# 3801 Stone Way N.

*Design Review Recommendation*

08/19/2013

DPD #3014111

① Aerial view looking into L1 Courtyard

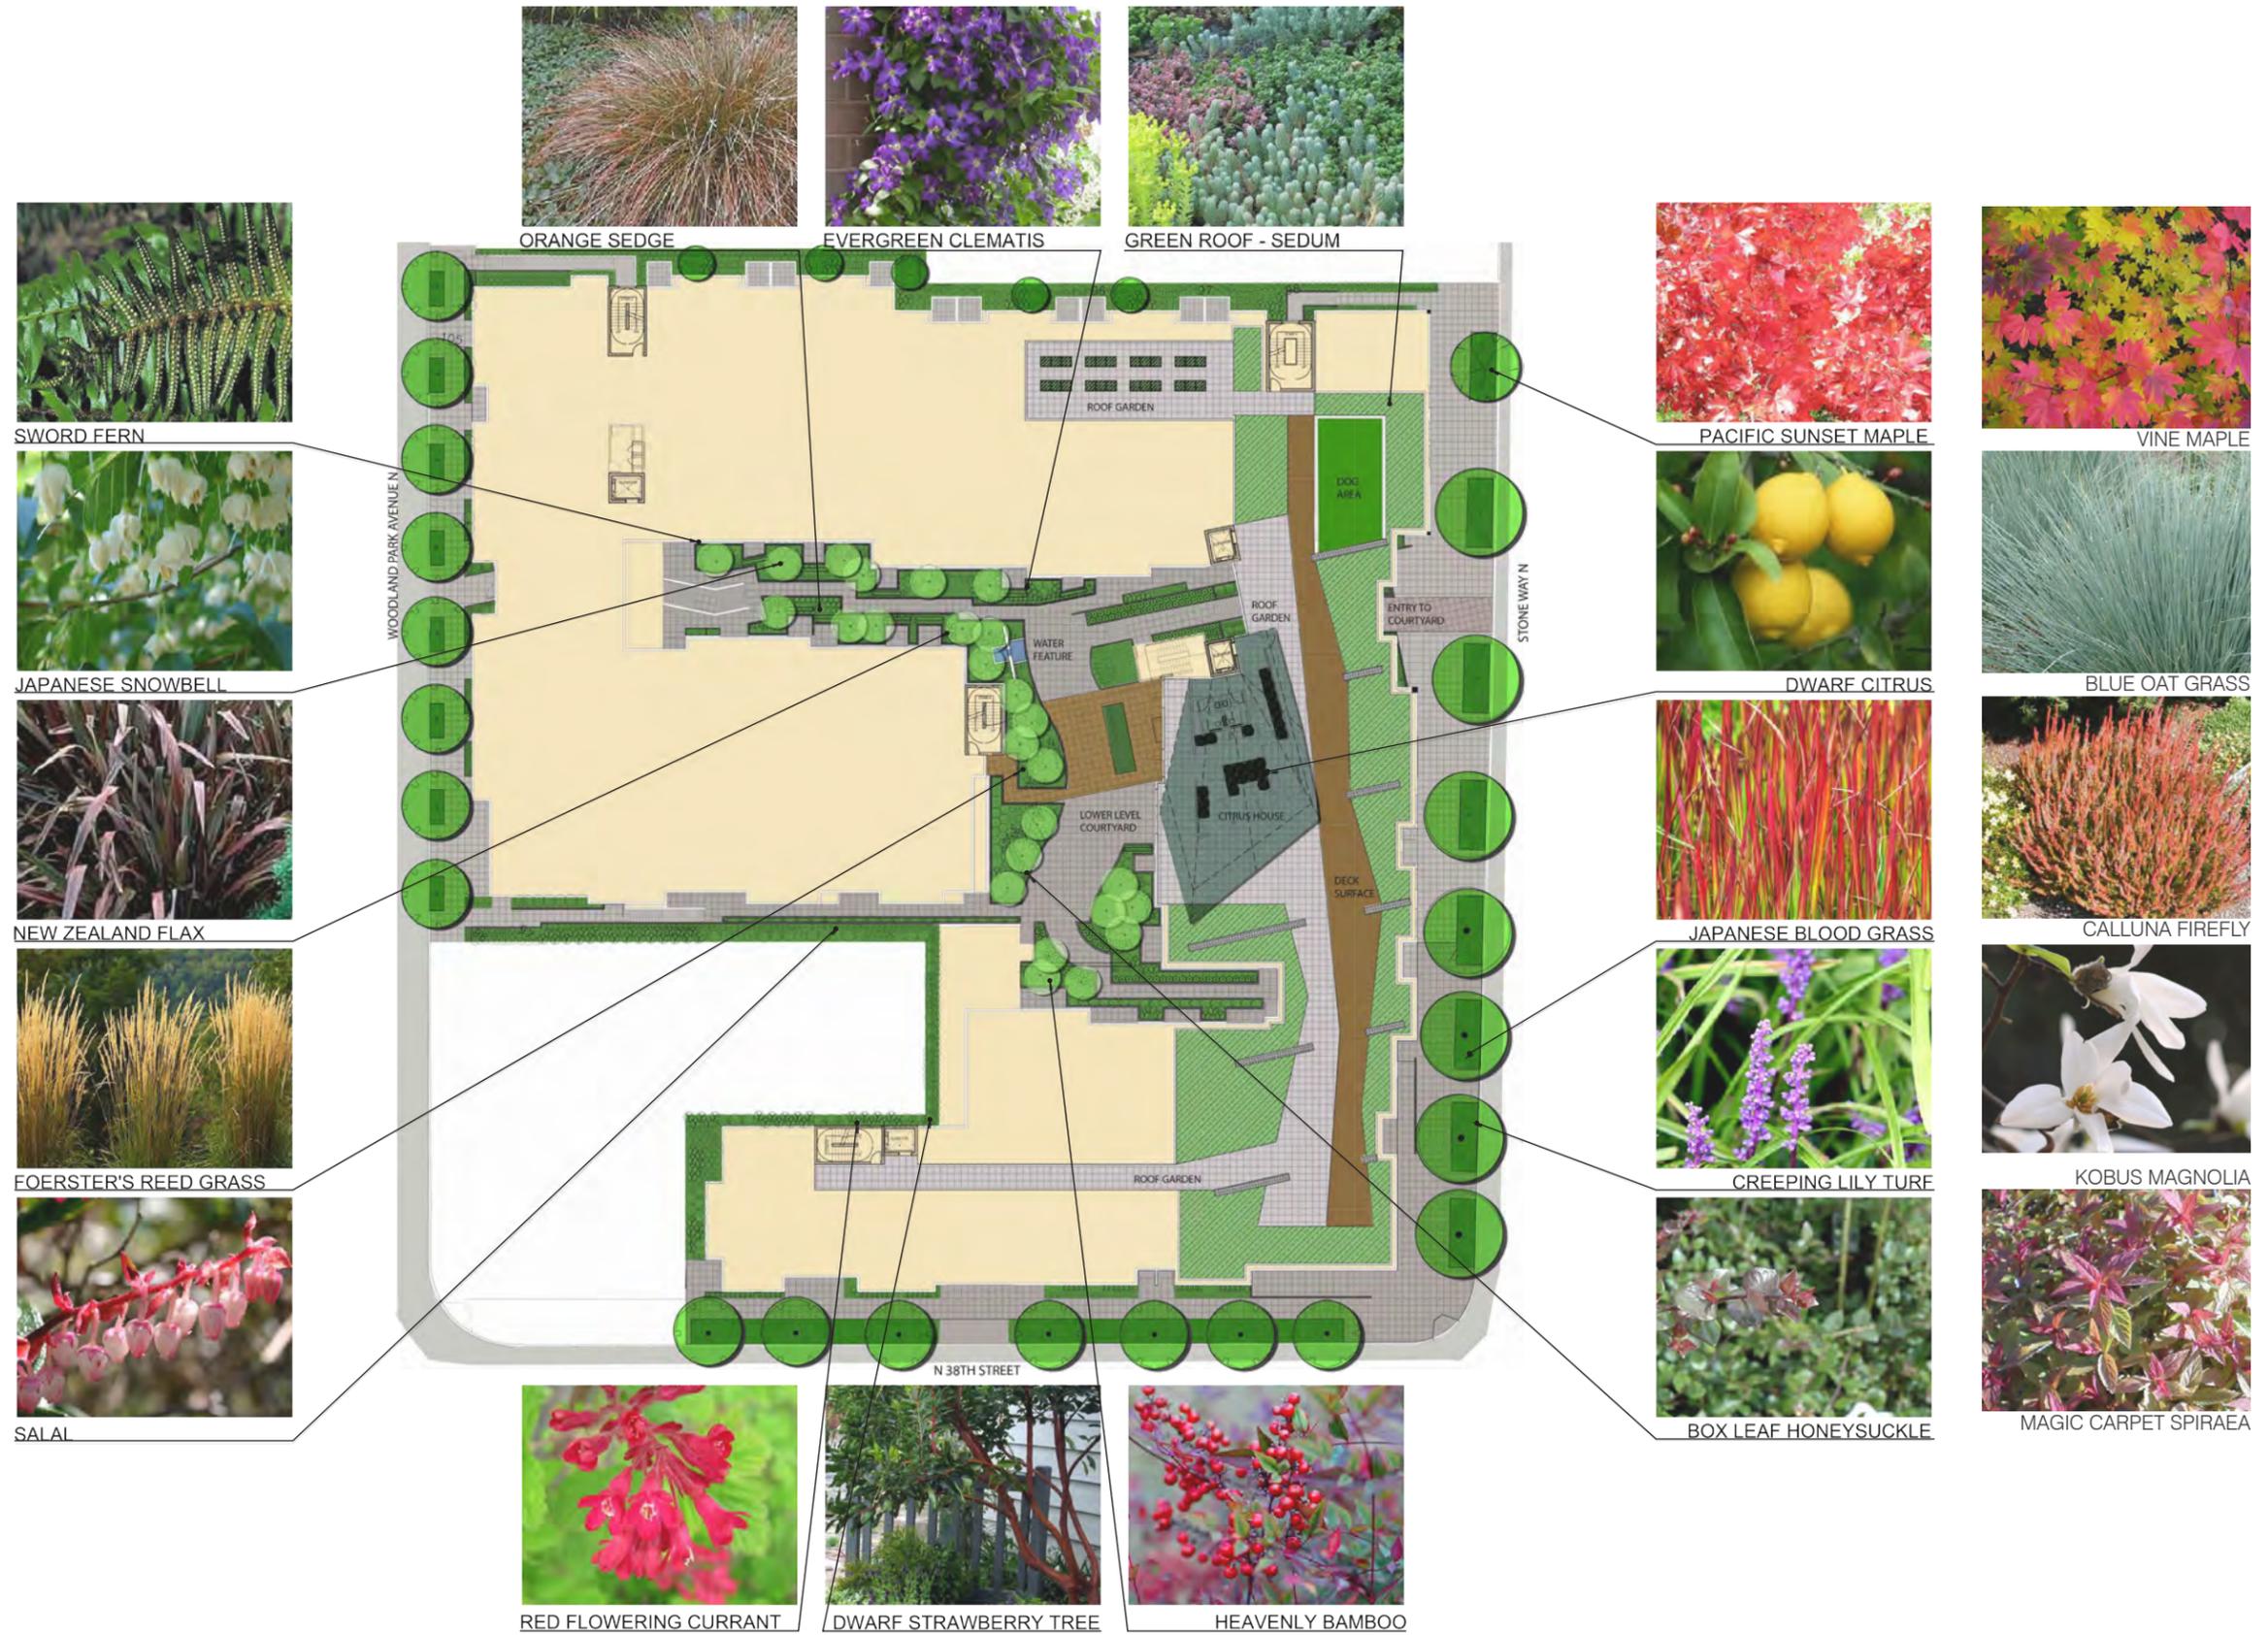
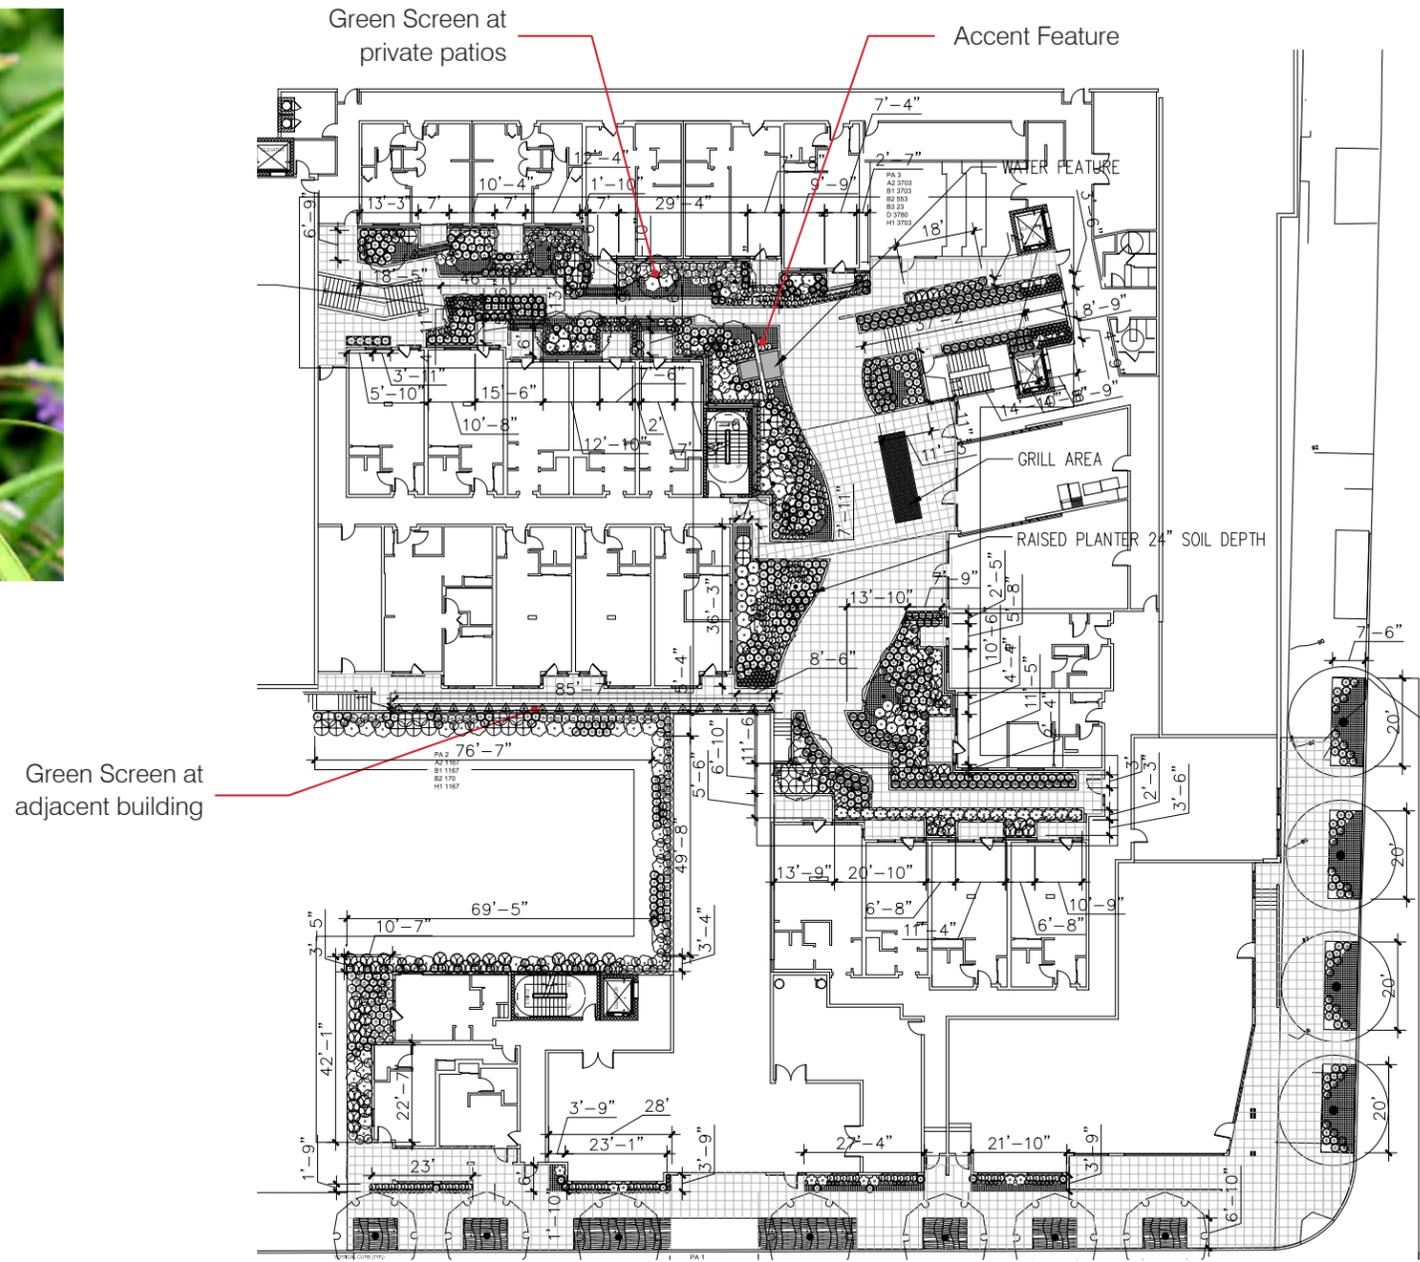
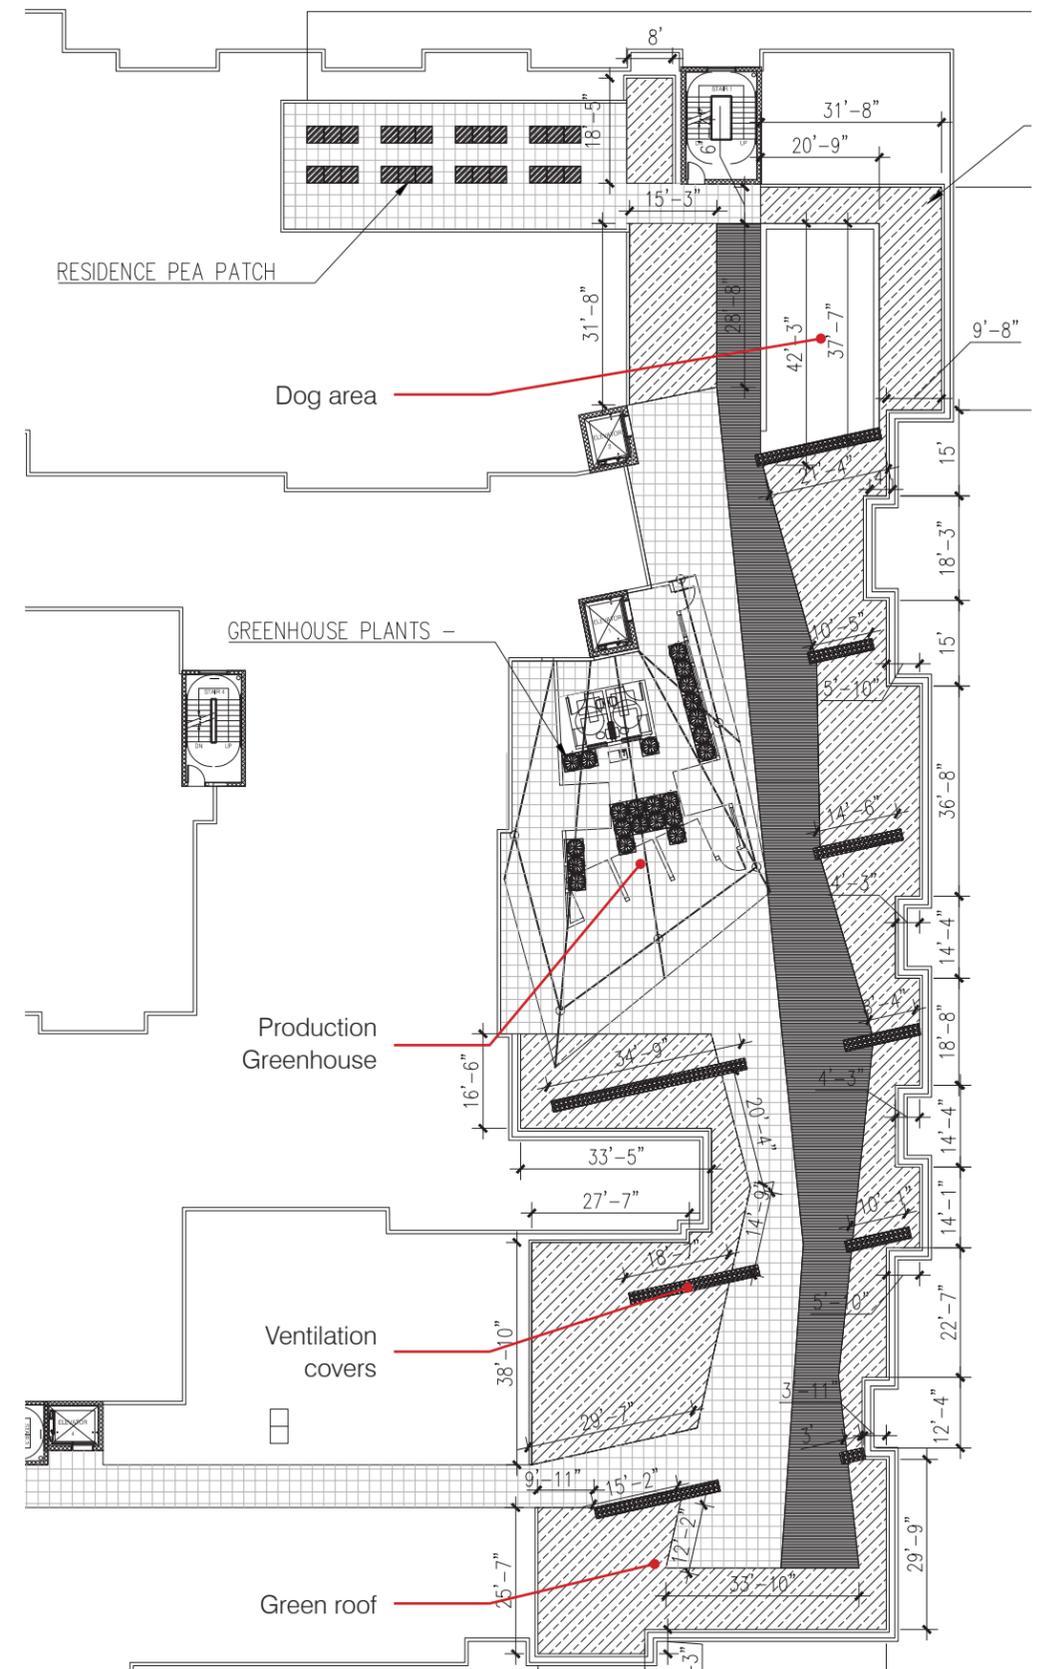
*DPD Correction #1: Landscaping to enhance the Building and/or Site. The landscaping plan continues to appear desultory without a focal point, amenities, and variety of materials. The lack of a strong parti for the court is reflected in the large expanse of concrete interrupted with small pates of vegetation. Most of the lower courtyard is circulation framed by landscaping pushed up against the elevations.*

1. The landscape has evolved in response to the critique.
2. Courtyard -The raised landscape beds have incorporated a softer curvilinear edge to create flow through the primary gathering spaces in the courtyard. The curvilinear edges are distinctive departure from the rigid geometry of the building. Raised landscape planting areas create privacy for private patios and units by creating an definitive edge and raising the plant materials closer to eye level. Numerous additional trees have been added to further increase privacy and diminish scale of the building. Vertical vegetated screens have been added to further increase privacy around private patios. The water feature has been repositioned to a location on axis with the stairs leading down from the Stone Way entrance to add immediate interest upon entry to the courtyard. The sound of the fountain should carry up the stairs toward the lobby entrance. The area outside the tenant amenity space has an alternate paving material and orientation to create a distinctive boundary for this area. This area is further enhanced by the addition of a barbecue countertop area.

3. Streetscape- Paving materials at the entry off Stone Way have a unique scoring orientation and will have a unique texture/color. Planting areas at the entry off Stone Way have been reduced to increase the area for pedestrians. The stairs leading up to the lobby entrance have been pushed into the site creating a larger entry space that relates to the sidewalk.
